Planning Commission Meeting Agenda
February 18, 2020
7:00 PM

THE MATTER OF THE LASALLE CROSSING APARTMENT, LLC SITE PLAN REVIEW APPLICATION (LU 417-2020)

The applicant has submitted a Site Plan Review proposal to expand the Lasalle Crossing Apartment complex with four (4) new 5-plex structures, totaling 20 new residential units, on the subject property located at 700 LaSalle Street.

C2

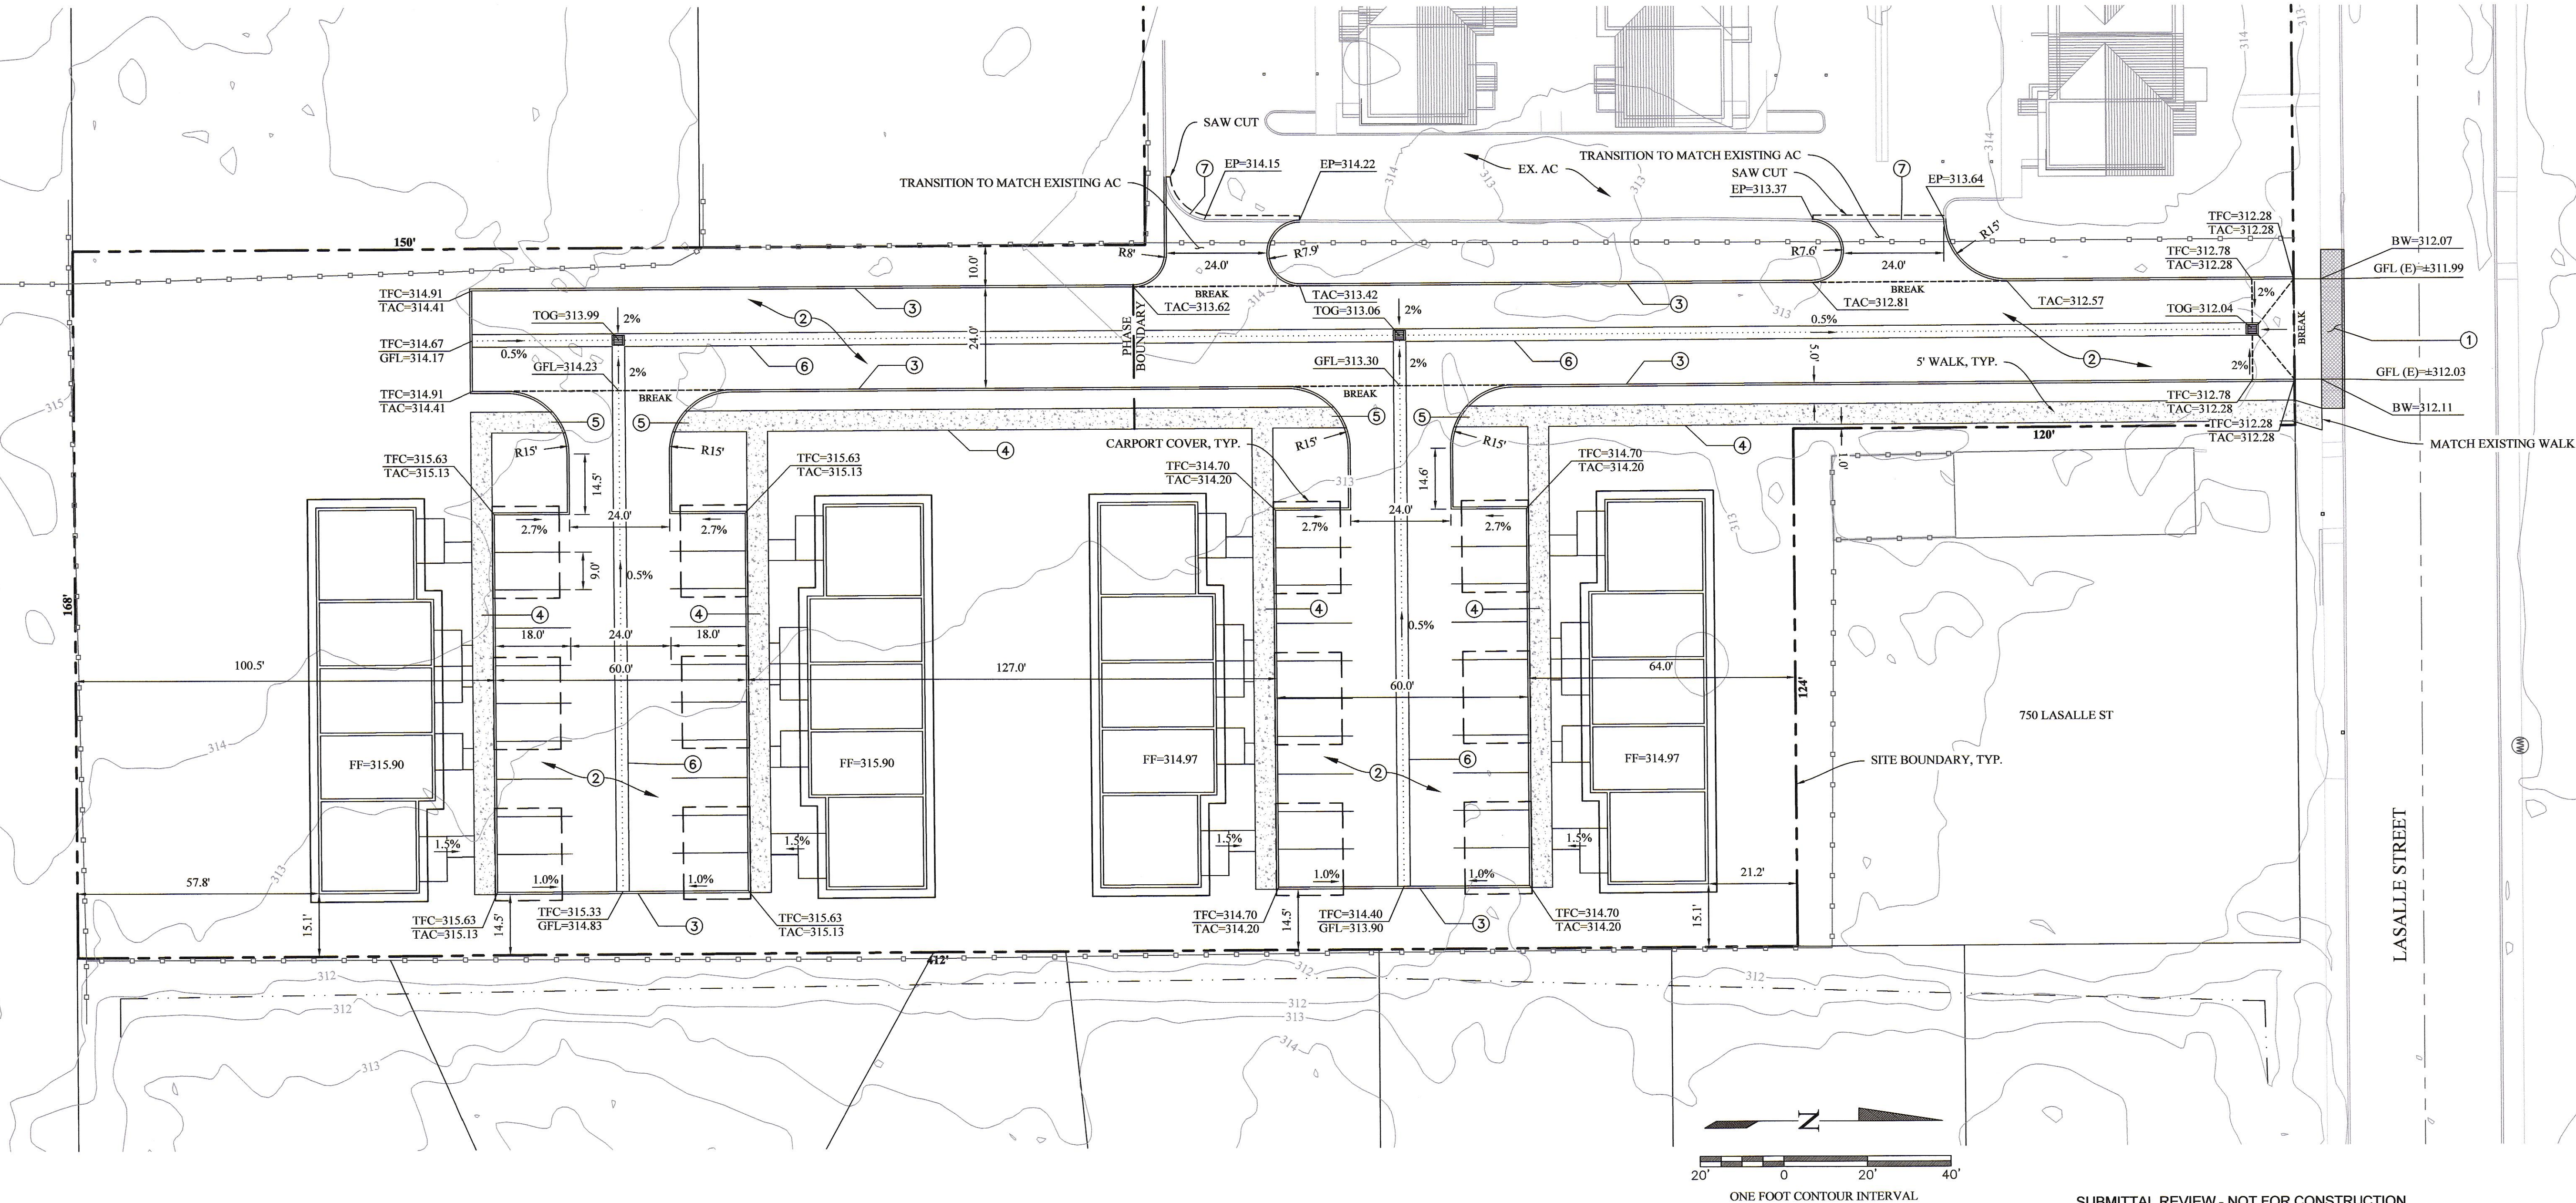
Stafford, AIA does not clearly delineate the parking areas from pedestrian facilities and landscaping areas. The table shown on the submitted Sheet A1 shows a total of 24 parking spaces (12 covered, 12 uncovered) for Phase-I (ten units total: four 3bdrm units, and six 2bdrm units). However, the Site Plan on A1 includes both Phases I and II, which will require a total of 40 off-street parking spaces in total for the 20 new dwelling units. It appears that the submitted site plan will still meet the minimum requirements, with the total off-street parking stalls provided at approximately 42 spaces.

Alternatively, the submitted Utility Plan - Site Grading and Paving Plan shows a different parking configuration, with no pedestrian walk at the east end of the Phase-I parking area, turn radiuses not impacting parking areas at the western edges of each lot, and a total of 40 parking spaces in compliance with the minimum parking standards at HMC 18.85.

For the purpose of this review, the Utility Plan - Site Grading and Paving Plan, Sheet C2, will be used to consider off-street parking areas (**Condition 2**) and shall be used as a reference when developing the construction documents. The configuration of parking areas shown on Site Plan Sheet A1 of this submittal is not approved and shall not be used for construction purposes.

Finding: As stated, the off-street parking areas shown on the Utility Plan are suitable in terms of size and location to serve the proposed use and shall be used for determining compliance with this criterion. This standard has been adequately addressed.

D3
3 of 4

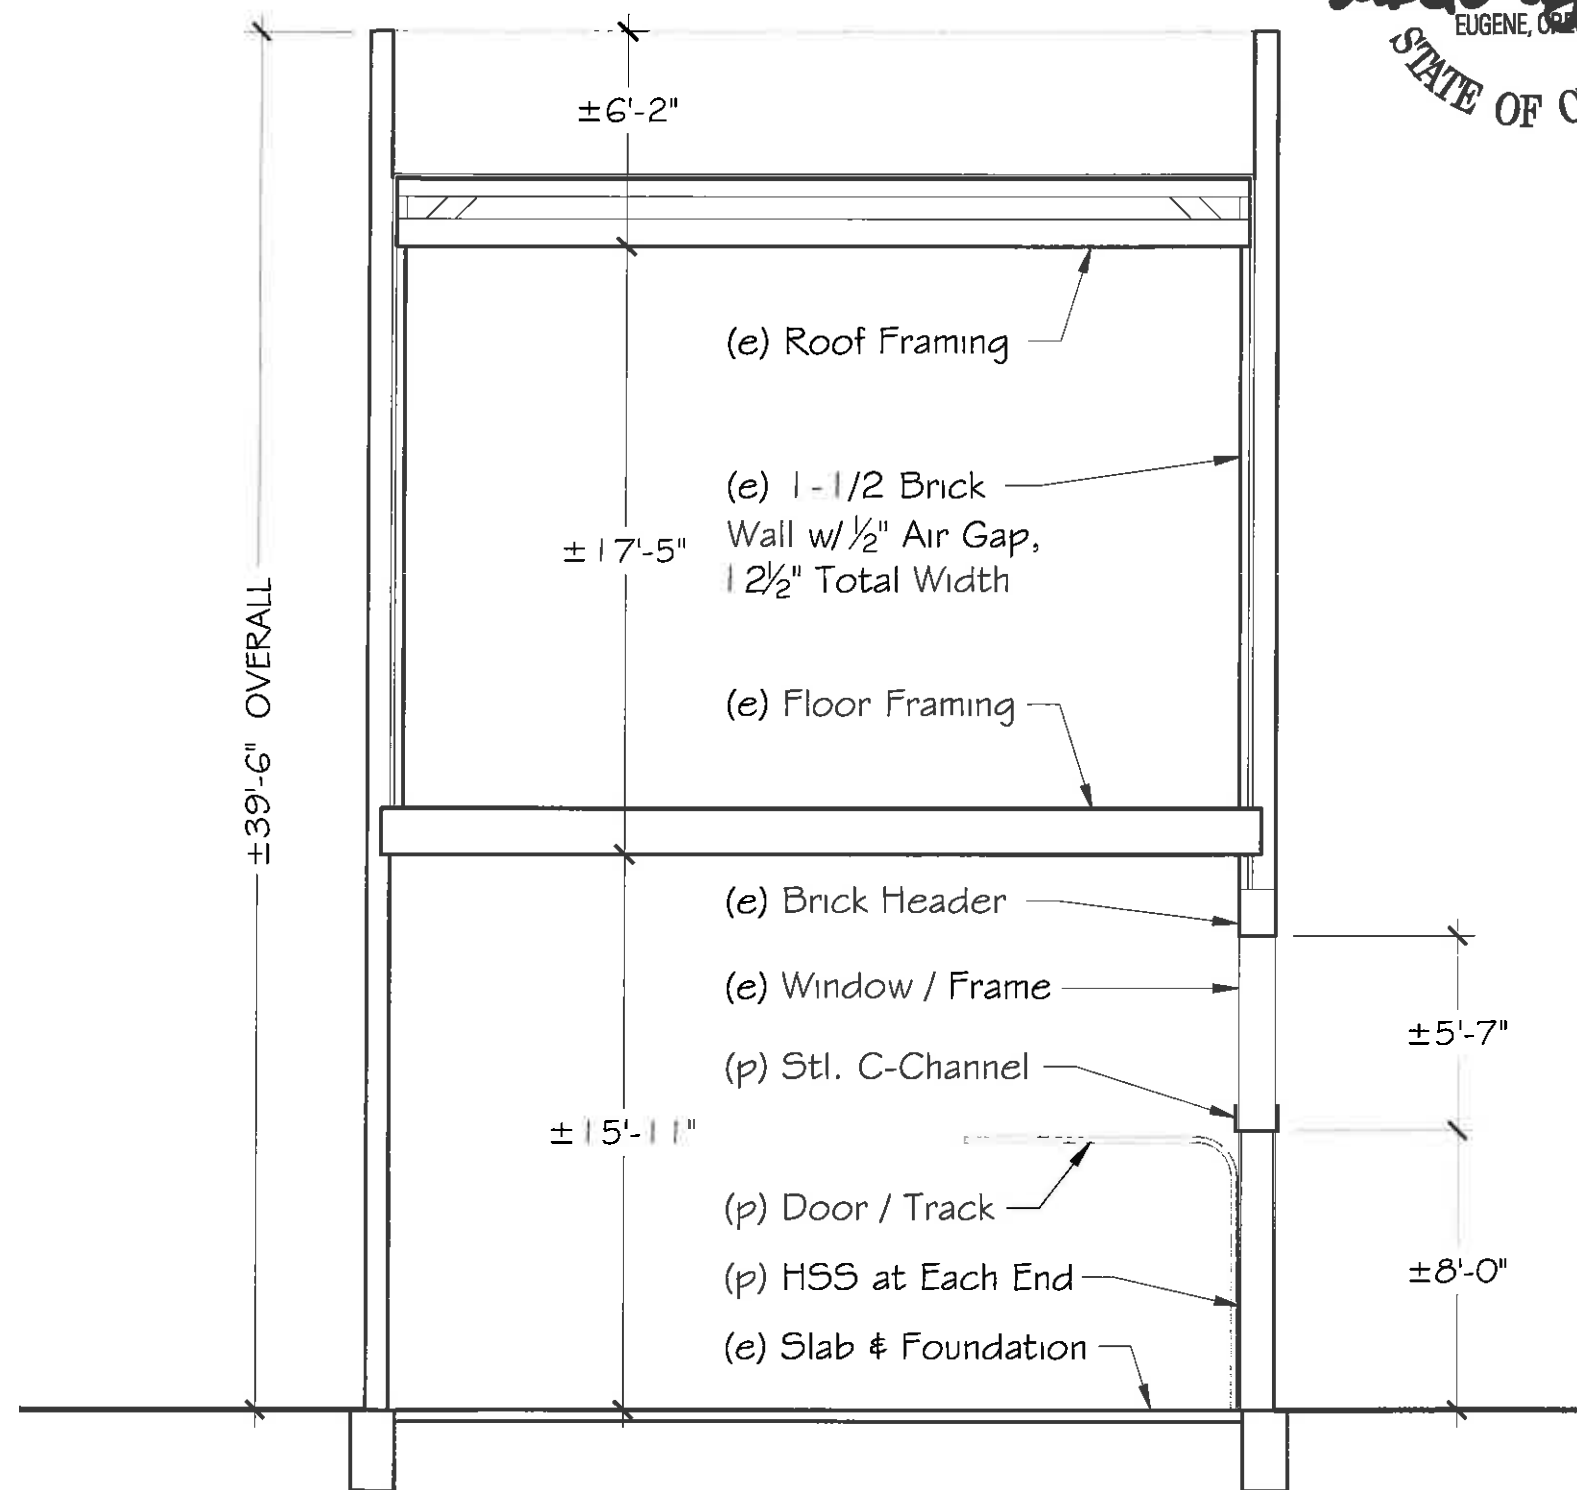
Finding: The elevations shown in the submitted Sheet D4 do not reflect a specific design in compliance with this standard. In addition, the City has received an email and information from the State Historic Preservation Office (SHPO), in relation to what kind of door would be acceptable to them. Therefore, if the Planning Commission determines that a Historic Alteration Permit is warranted based on the findings presented, the following Condition of Approval (**Condition 1**) is recommended:
